City of Ryde Submission

161 Herring Road & 13-15 Lachlan Avenue,
Macquarie Park

SSD-74319712: Infill Affordable Housing

Submission Date: 17 April 2025

Figure 1: Markup of DKO Shadow Diagrams (Base Source: Appendix 6 – DKO)

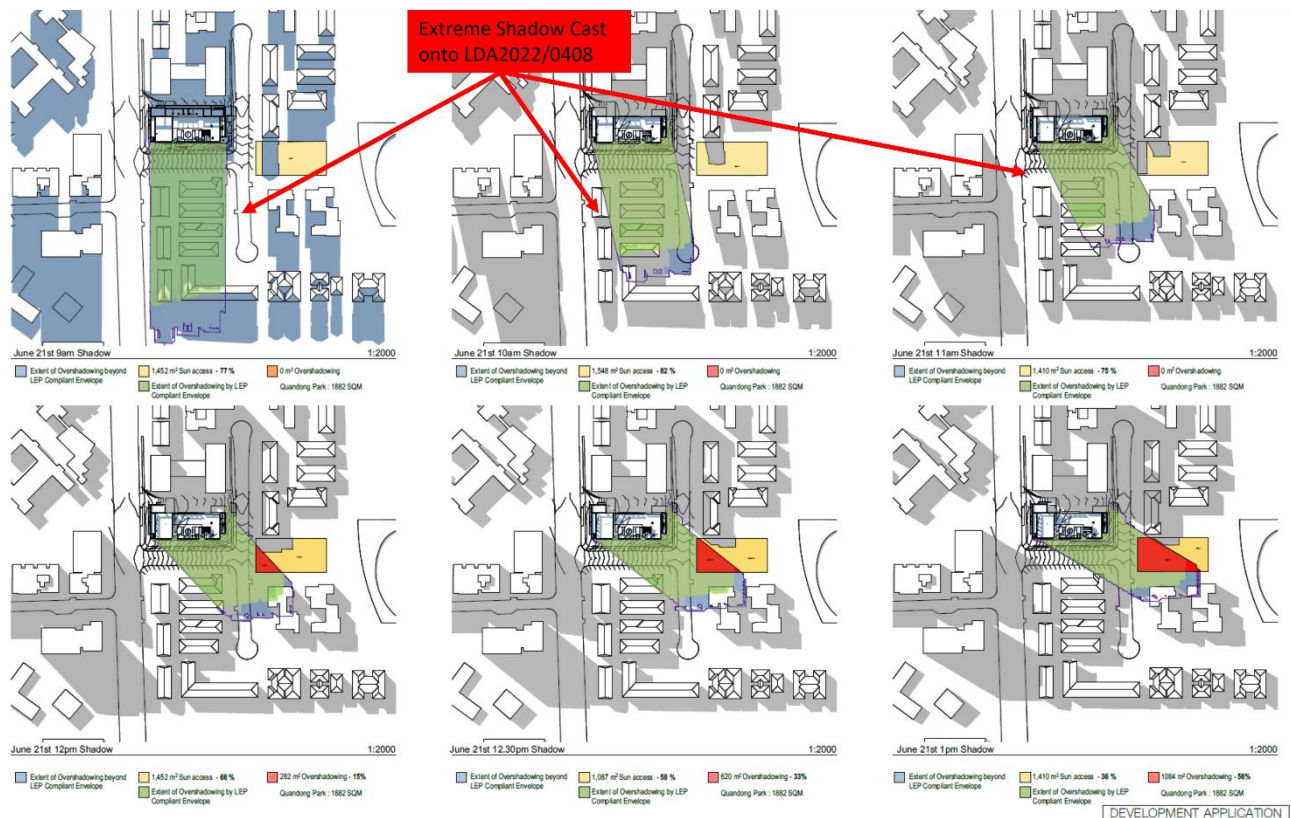
The Application does not consider this receiver in its solar modeling and shows the site within its solar modeling shown as the proposed built form outcome under LDA2022/0408. The sites most significant shadow impact is from 9am – 12am, where LDA2022/0408 communal open space is entirely cast in shadow and without solar access.

This shadow cast is exacerbated by the fact that LDA2022/0408 only available solar access is from 9am – 11am. Land associated with LDA2022/0408 would be 100% cast in shadow during winter months as a result of the SSD proposal.

It is recommended that the central section of the development is reduced sufficiently (possible by at least 4 storeys although this should be explored by shadow diagrams to ascertain the most appropriate reduction) to enable sunlight access to continue to penetrate into the neighbouring communal open space area during this time.
